CITY OF TULSA
PUBLIC WORKS
Engineering

ADDENDUM NO. 4

ADDENDUM NO. 4
TO
PROJECT NO. 2036W0001Z, 2036A0024Z & TMUA-W 22-37
ARTERIAL STREET RECONSTRUCTION GILCREASE MUSEUM RD. (N. 25th W. AVE.) W. ADMIRAL BLVD. TO W. PINE ST.

ADDENDUM NO. 4
TO
GILCREASE MUSEUM RD.
(N. 25TH W. AVE.)
W. ADMIRAL BLVD TO W. PINE ST.
PROJECT NOS. 2036W001Z, 2036 A0024Z & TMUA-W 22-37

TYPICAL NO. 1
STA. 114+92.02 TO STA. 122+52.03

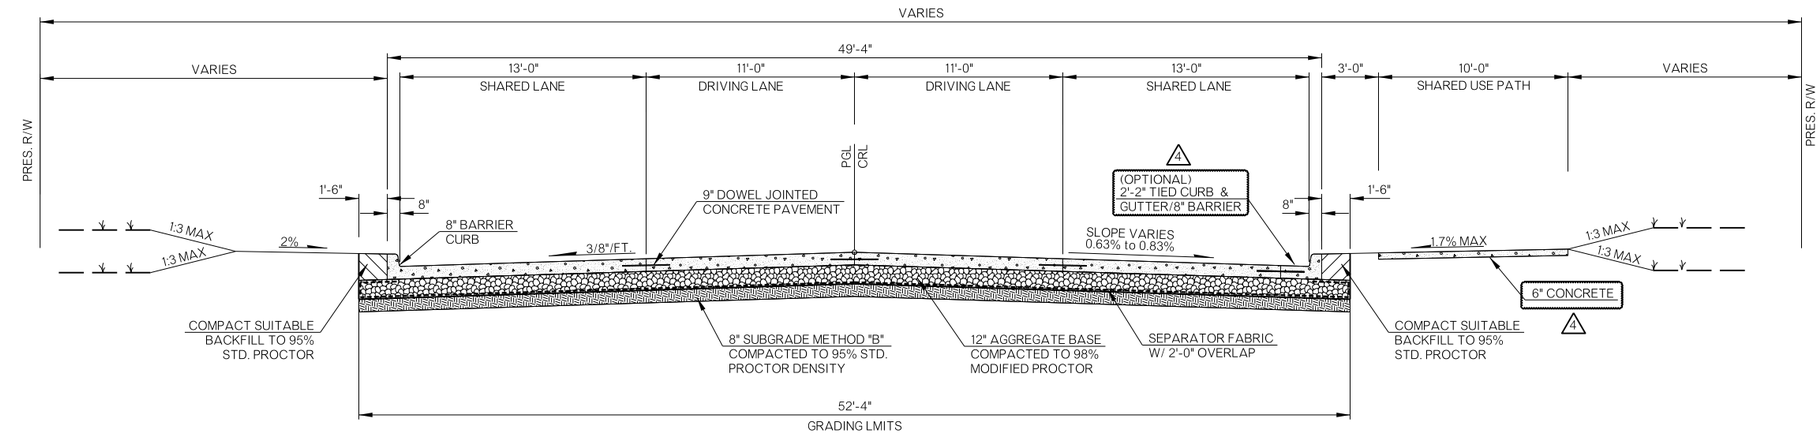
- No. 8 removing callout note “CRACK SEALING AS DIRECTED” from TYPICAL NO. 1.
- Nos. 8 to14 with revised callout note changing “1’-6” TIED CURB AND GUTTER…” to “2’-2” TIED CURB AND GUTTER…” and Trail has revised callout note changing from “4” CONCRETE” to “6” CONCRETE”.

REVISION	BY	DATE
4 ADDENDUM 4 - MODIFIED SIDEWALK, CURB AND GUTTER, AND CRACK SEAL NOTE	JTB	08/01/2025

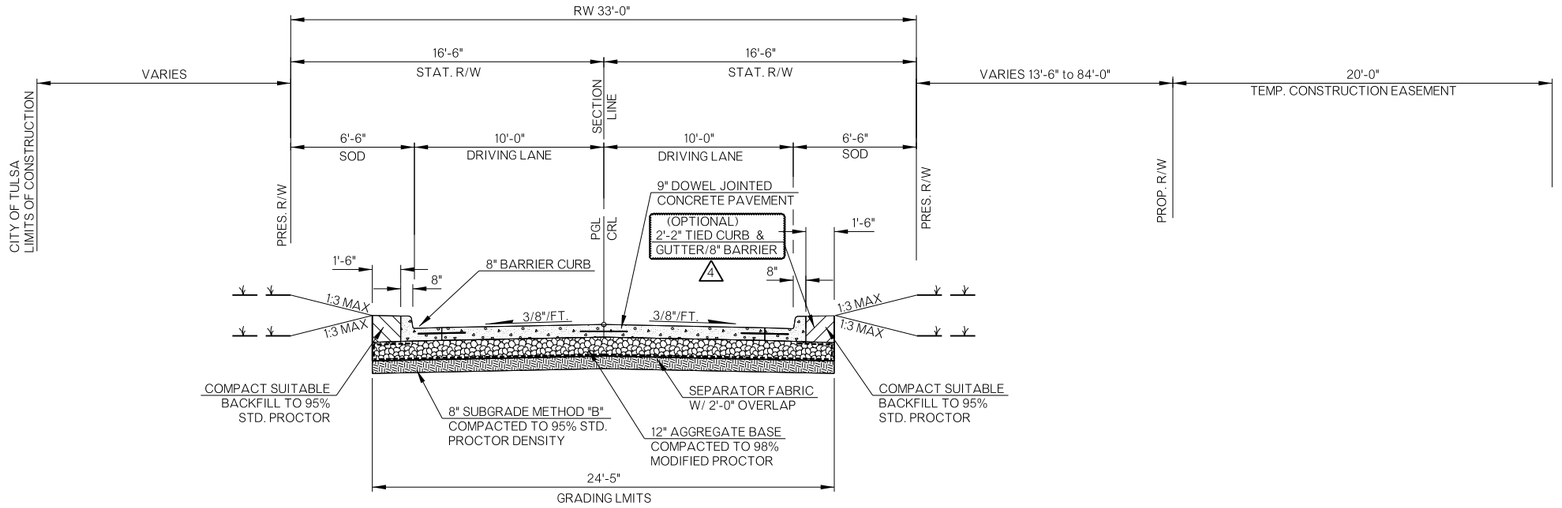
- No. 14 with revised callout note changing “SPECIAL DITCH SEE DETAIL” to “6’ WIDE DITCH, ODOT DC-4 DESIGN 2A, Quantities: 187 LF of CLASS C CONCRETE”. Additional 22 CY of Class C Concrete is added to Bid Item 22.

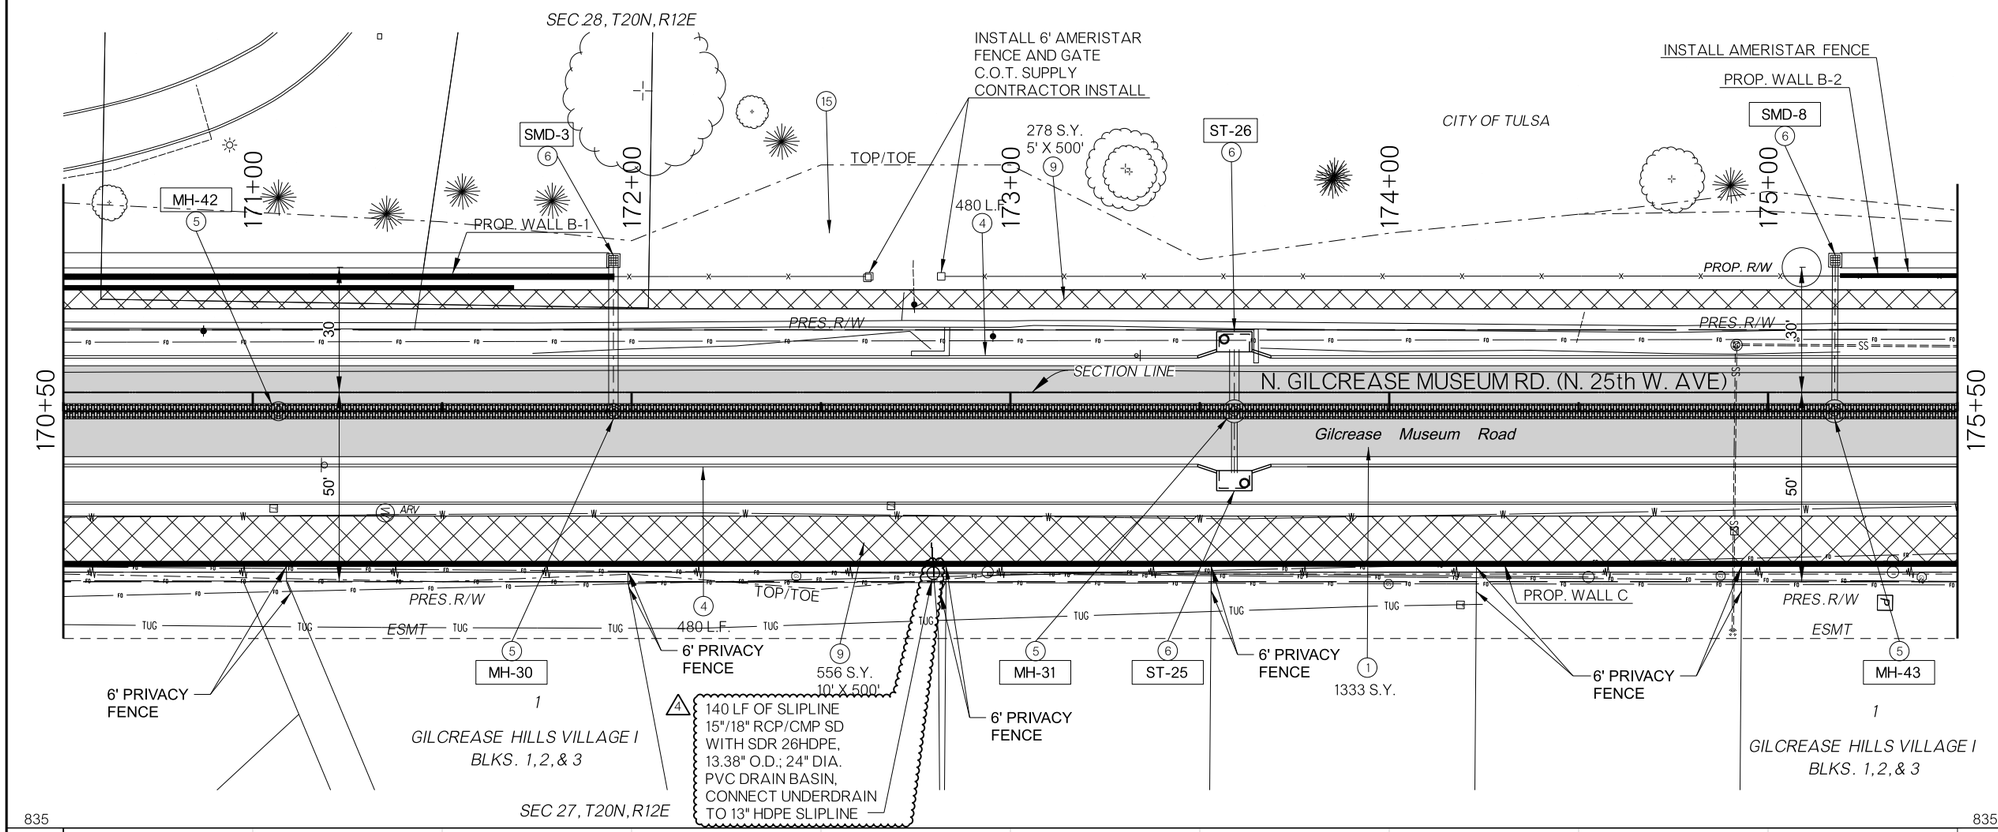
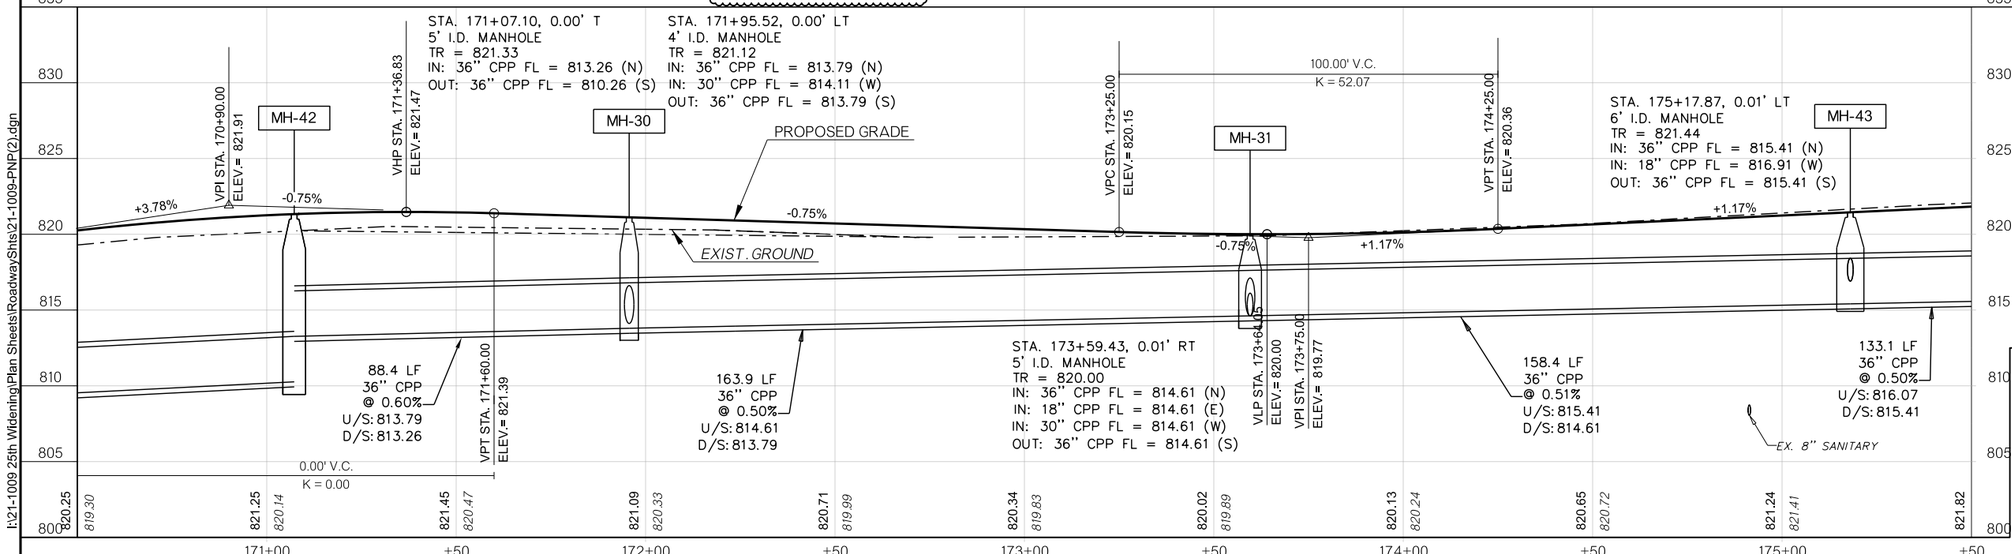
- No. 47 with added inlet SMD-2, manhole ST44A, and 40 LF of 18” CPP storm drain at south end of Retaining Wall B1. Also added storm drain, 7 LF of 24”CPP connecting to existing inlet ST-24A from ST-24.

FILE: H:\21-1009 DRAWING: 21-1009-PNP-NEWTON DATE:
ATLAS PAGE NO: 19, 20, 21, 42, 43, 74, 75 SHEET 51 OF 268 SHEETS

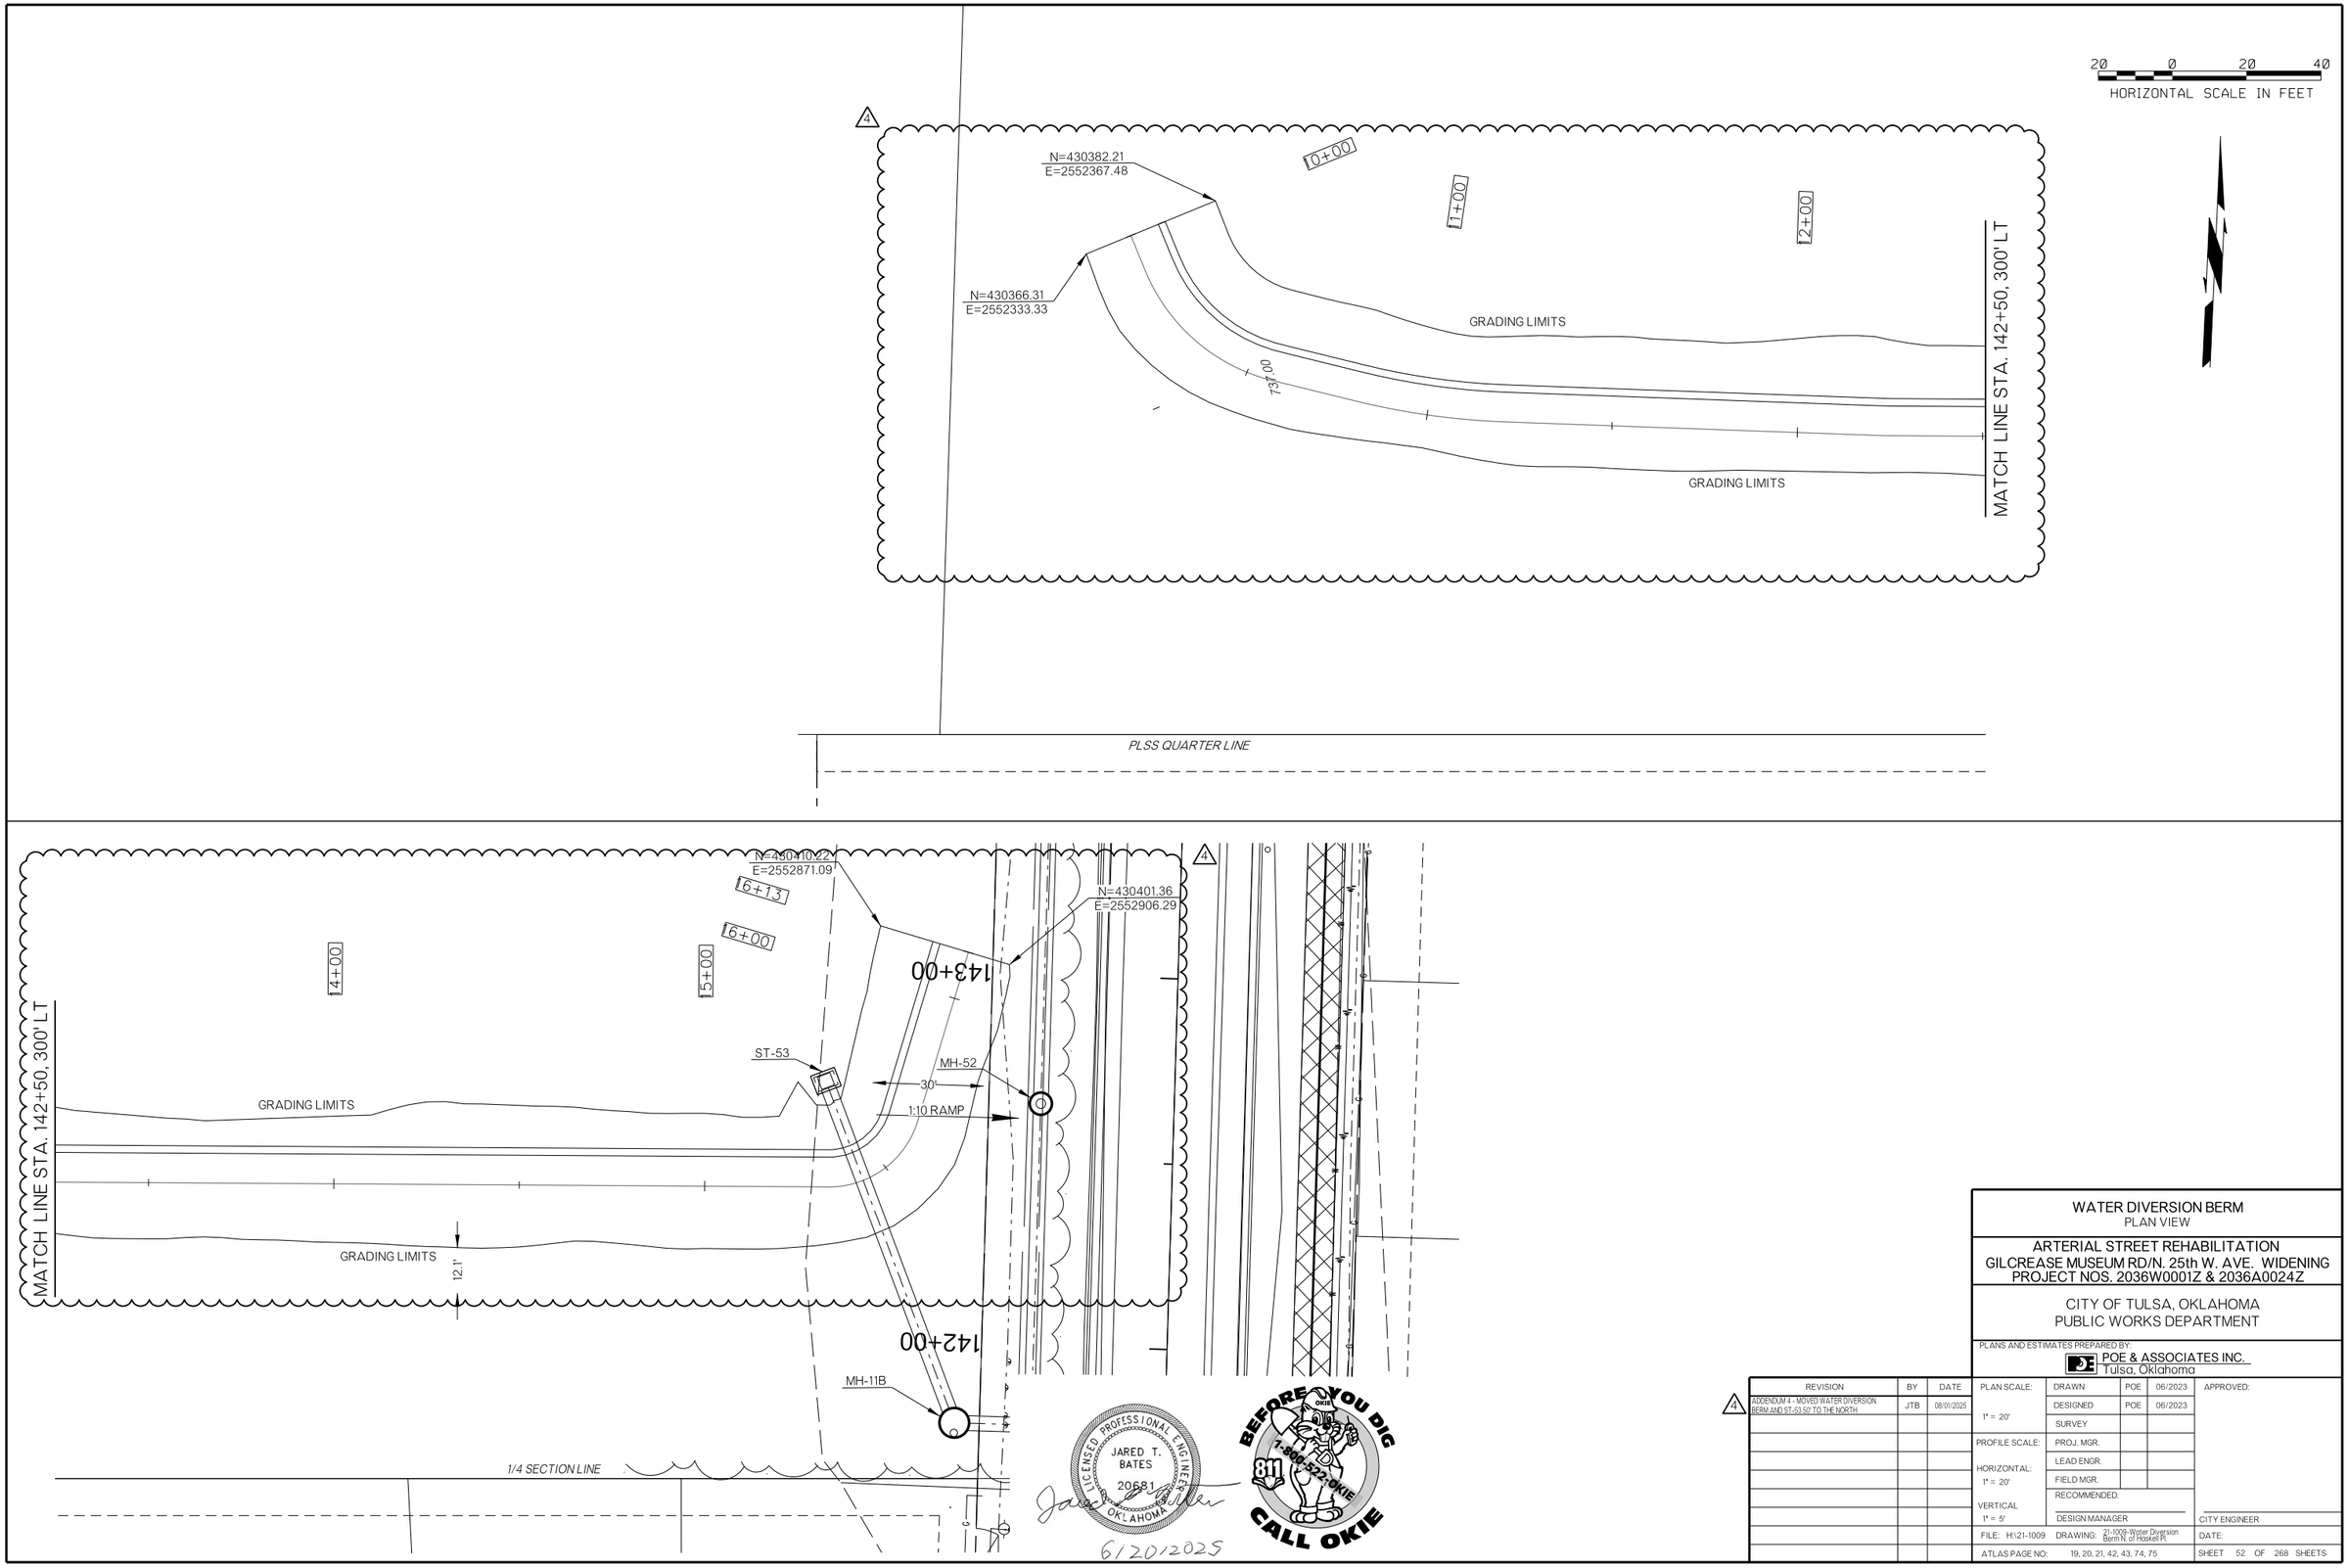
- corrected vertical curve numbers at 178+00.
- No. 51 with added 42 LF of 24” RCP culvert and precast end sections under Temple driveway. Added bid items 214 and 215.

FILE: H:\21-1009 DRAWING: 21-1009-Removals DATE:
ATLAS PAGE NO: 19, 20, 21, 42, 43, 74, 75
SHEET 59 OF 268 SHEETS

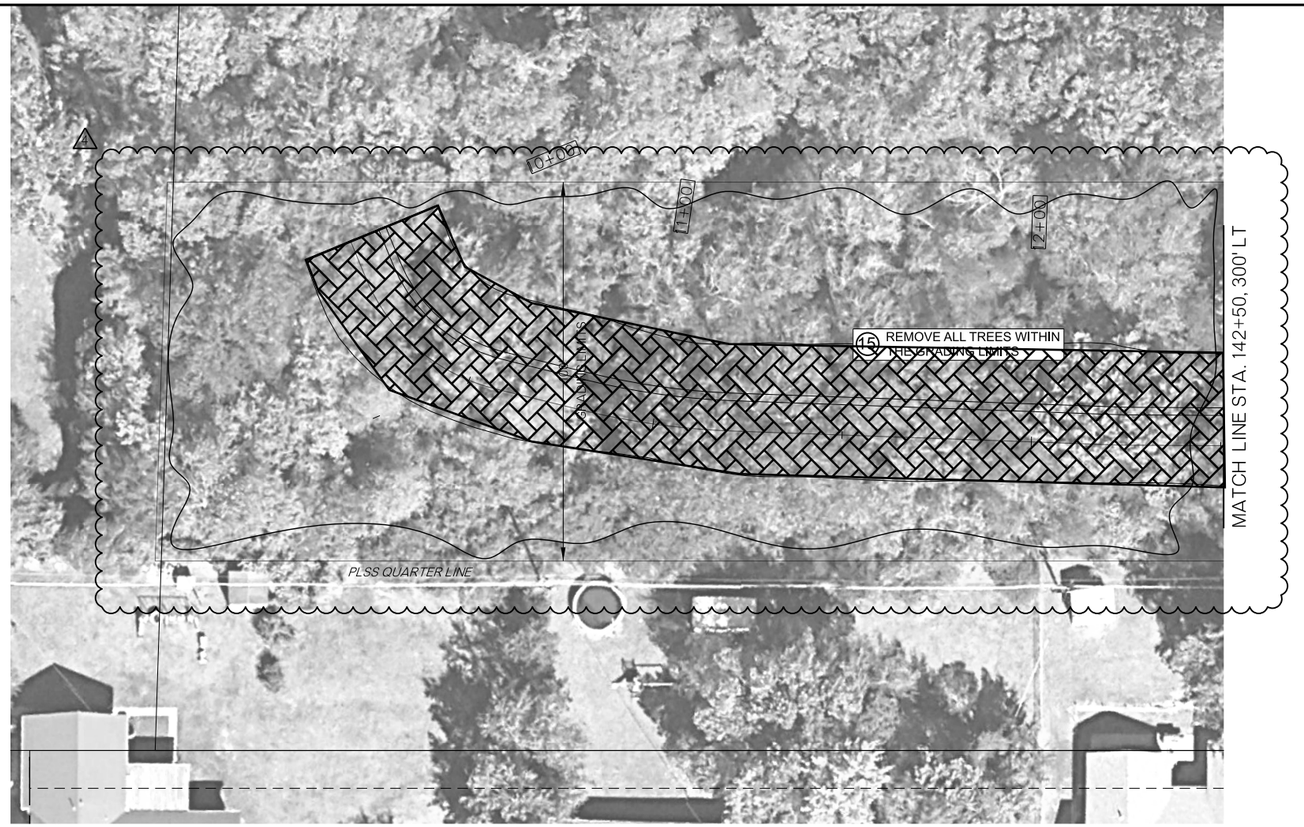
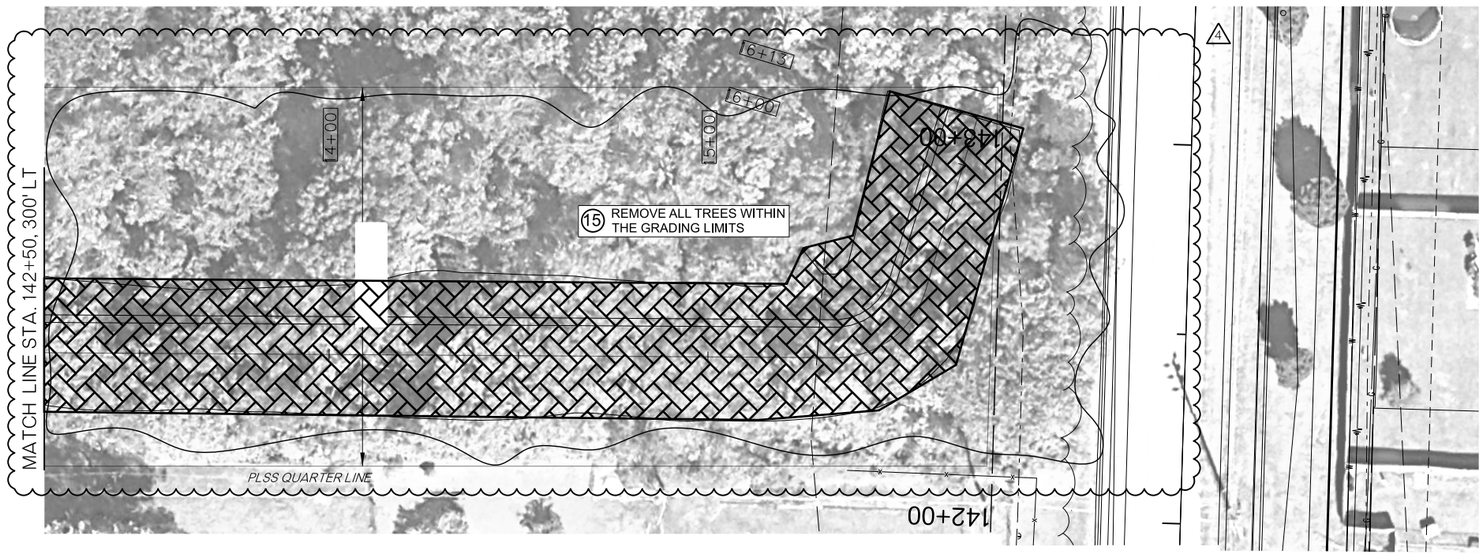
- No. 59 with added note for existing storm drain to remain in place for Sliplining at Sta 172+80, 50'RT.
- No. 62 with diversion swale/berm cleared forest area shifted 50' north; total area of clearing is unchanged.
